# Memorandum to the City of Markham Committee of Adjustment

**File:** A.073.20  
**Address:** 72 Royal Orchard Blvd – Markham, ON  
**Applicant:** Chris Mandarino  
**Agent:** JS Barmi Architect  
**Hearing Date:** Wednesday September 16, 2020

The applicant is proposing to construct a 33.15 m<sup>2</sup> (356.84 ft<sup>2</sup>) second floor addition located at the front southwest corner of the existing dwelling. Accordingly, the applicant is requesting setback relief of 0.61 m (2.0 ft) along the western property line where the two-storey portion is being proposed.

EXISTING SITE PLAN

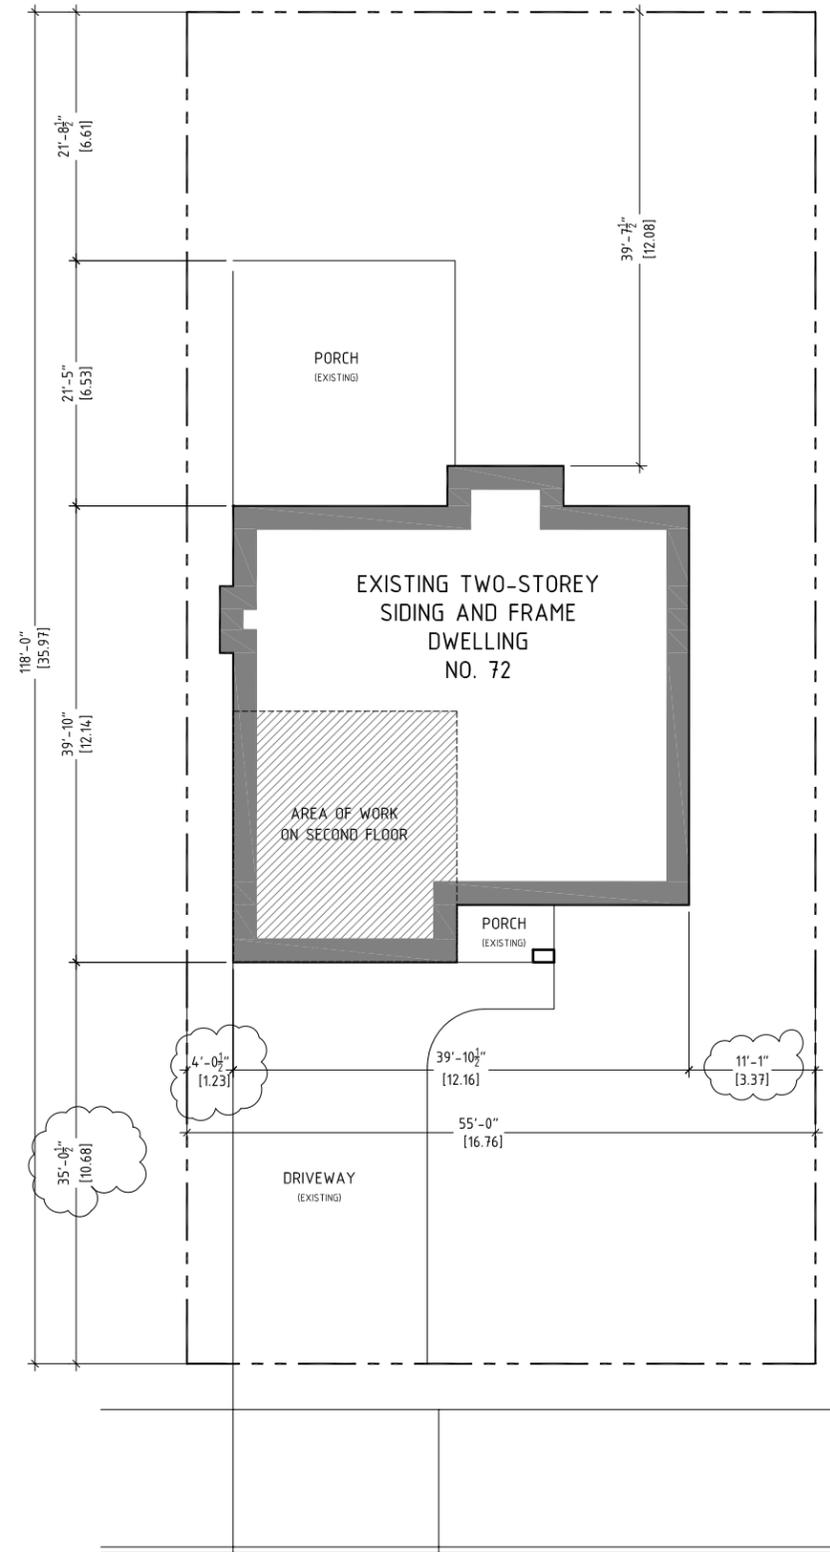
The applicant is requesting a minimum westerly interior side yard setback of 1.22 m (4.0 ft) for the two-storey portion of the dwelling, whereas the By-law requires a minimum side yard setback of 1.83 m (6.0 ft) on each side except that the minimum side yard required for a one-storey portion shall be 1.22 m (4.0 ft).

The existing dwelling's building line nearest the west property line is one-storey in height, and is setback approximately 1.22 m (4.0 ft). The requested variance applies to the proposed second storey addition to the existing building along the west property line. The addition would have a depth of 6.07 m (19.91 ft) from the front of the dwelling as shown in the plans attached as Appendix "B". Staff are of the opinion that the requested variance is a minor building addition that would not adversely impact the neighbouring dwelling or street, and do not object to the requested variance.

Planning staff have reviewed the application with respect to Section 45(1) of the *Planning Act, R.S.O. 1990, c. P.13, as amended*, and are of the opinion that the variance request to permit a reduced side yard setback of 1.22 m (4.0 ft.) meets the four tests of the
